SUBJECT: Mississippi River Ship Channel, Gulf to Baton Rouge, Louisiana

PURPOSE Mississippi River Ship Channel - Mitigation Plan  
Discussion of comments by HQUSACE and WLRC

WEST BANK SALTWATER MITIGATION  
RESERVOIR PLAN  
PIPELINE  
FROM POINTE A LA HACHE  
TO BOOTHVILLE

FIGURE 2

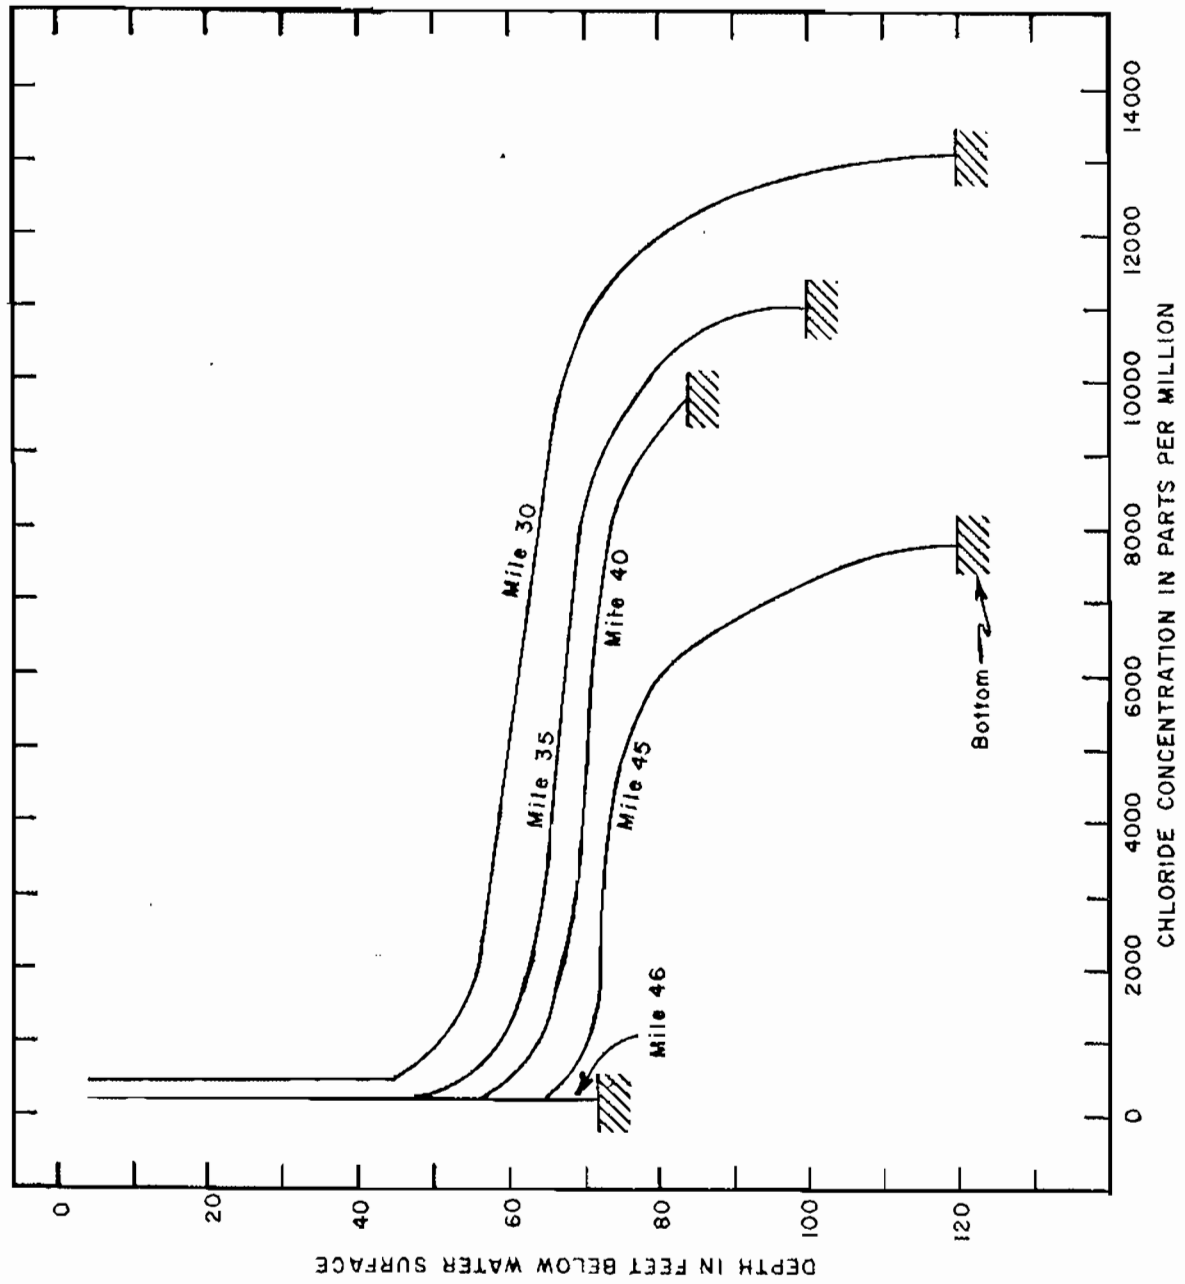
c. Page 5, para 10. The reference to Figure 2 for stratification should be 65-foot depth - 1000 ppm or 45-foot depth - 100 ppm.
